## General Information

A new design for the Saf-T-Liner C2 grille went into production on February 5, 2018. The hood design has also changed slightly to accommodate a different grille fastening strategy. The old grille and hood part numbers will no longer be produced, and will supersede to the new design with new part numbers.

## Grille Replacement

**Fig. 1, Grille Installation**

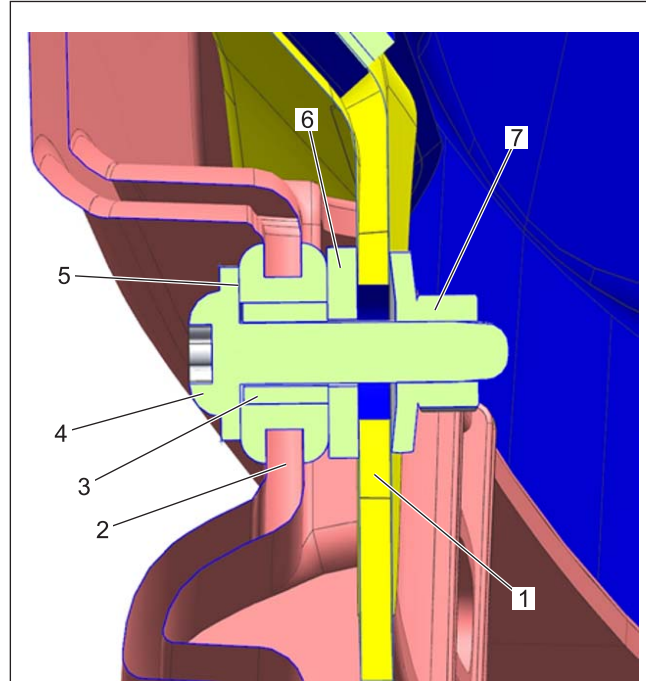
To replace a grille on a hood from a vehicle built prior to February 5, 2018, the additional fasteners shown in [Table 1](#) must be used. See [Fig. 1](#) and [Fig. 2](#). Parts are available at the PDCs.

The old grille does not fit on the new hood design. If the old hood design is not available, a new grille is required when replacing a hood on a vehicle built prior to February 5, 2018.

1. Park the vehicle on a level surface, shut down the engine, and set the parking brake. Chock the tires.
2. Remove the four screws that attach the grille to the hood, and discard them.
3. Remove the isolated nuts from the hood, and discard them.
4. Install the new grille, with the new washers between the grille and the hood, then attach it to the hood with the new screws and nut/conical washer assemblies. Tighten the nuts 60 to 84 lbf-in (680 to 950 N-cm).
